Re: Basin Electric Power Cooperative
Case No. PU-24-61 Leland Olds Station to Tande 345-kV Transmission Line Application
Amendment

**Amendment to the Application to the North
Dakota Public Service Commission for a
Certificate of Corridor Compatibility and Route
Permit**

**Leland Olds Station to Tande 345-kV
Transmission Line
Basin Electric Power Cooperative
Mercer, McLean, Ward, Mountrail, and Williams
Counties, North Dakota**

PU-24-361

Figure 1-1: Reroute Number 1

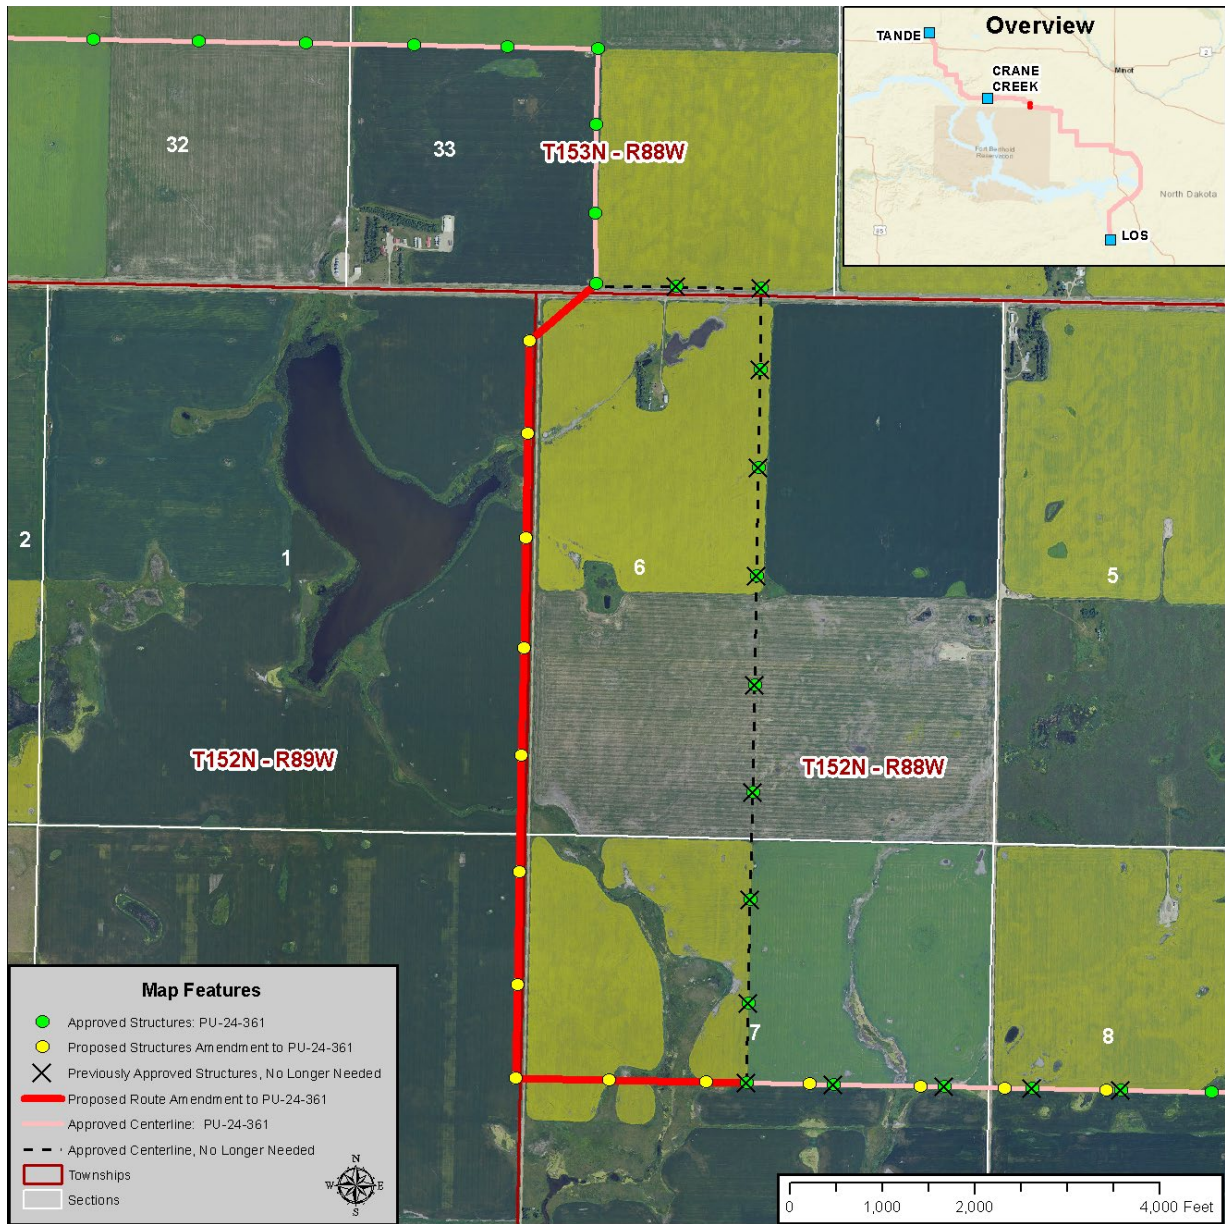
Reroute number 1, originally an approximately 1.98-mile segment with nine structures, is 2.16 miles in length with 10 structures.

Figure 1-2: Reroute Number 2

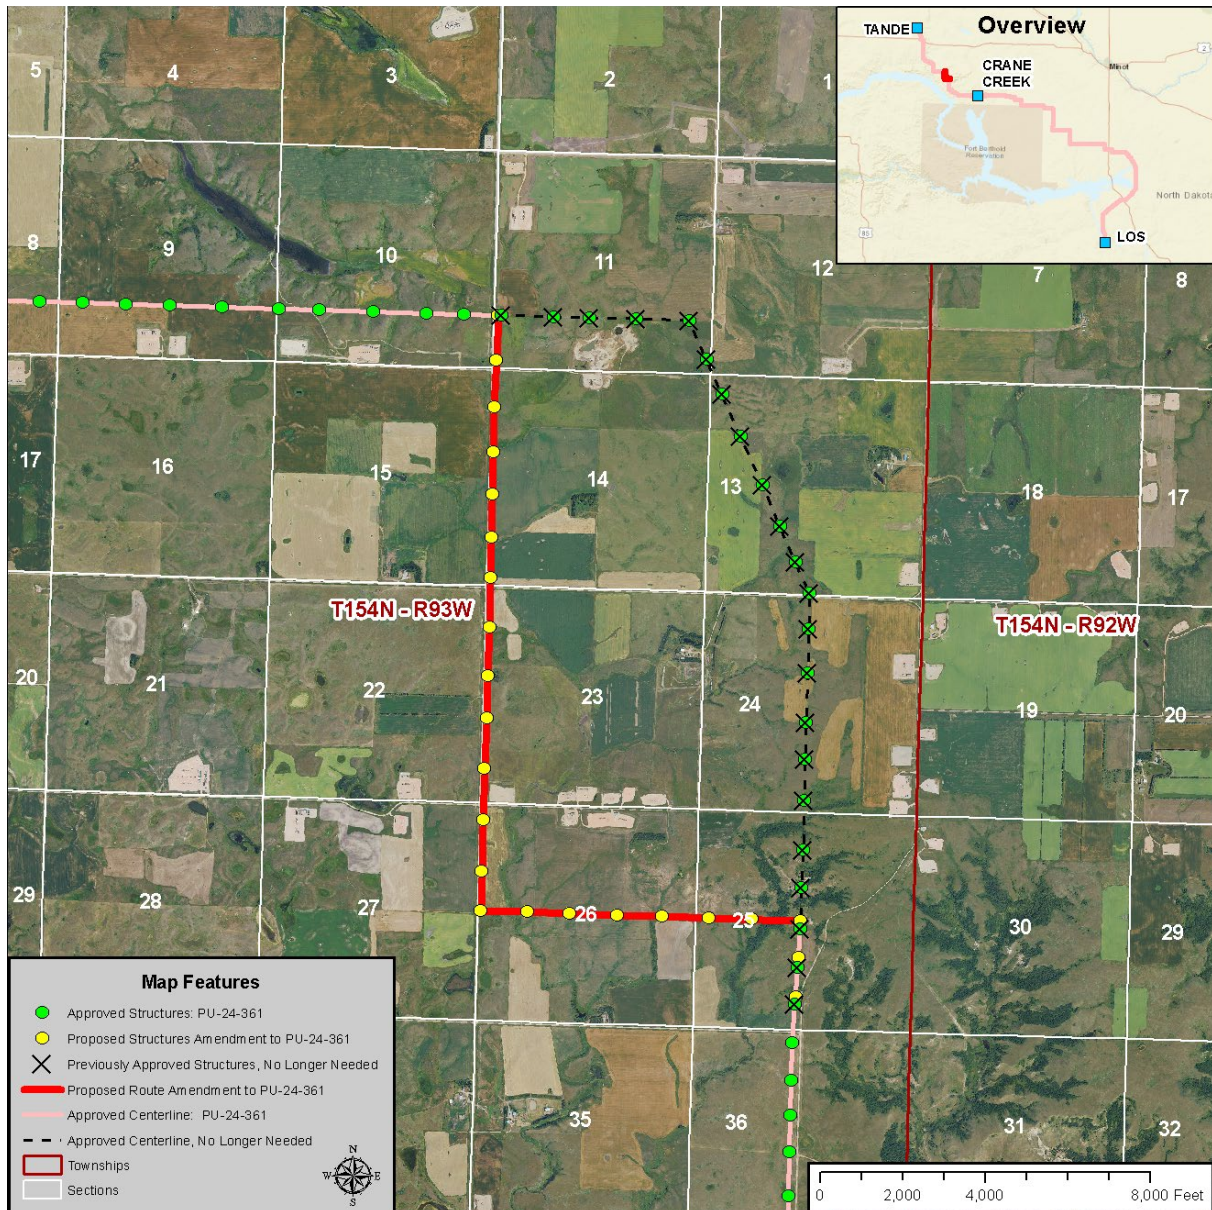
Reroute number 2, originally an approximately 3.74-mile segment with 19 structures, is 4.20 miles in length with 19 structures.
